## EMBREY BUILDERS, LLC.

RFI

Job: EB-02 Keller Springs Lofts Phone: 877-777-5115

Drawing: 9/A2.2, A3.1E & 19/A8.2 Cost Impact: None

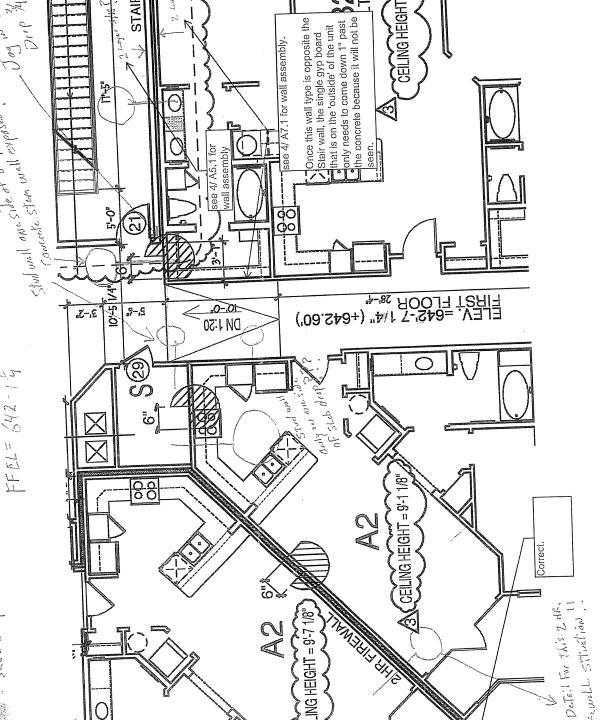
Date Required: 4/11/2012 9/A2.2 shows a signle Mark H window in the bedroom. A3.1E shows a twin window in the bedroom and has the window pushed to the brick per 19/A8.2. What is the correct window and placement of the window? Requested by: David Miller Embrey Builders LLC

A1 unit plans on 2.2 are dimensioned accurately. (I added it at the end of this PDF just for reference, but this RFI has not changed that sheet) Sheer 3.1E has been updated to coordinate. Please see next page of this PDF.
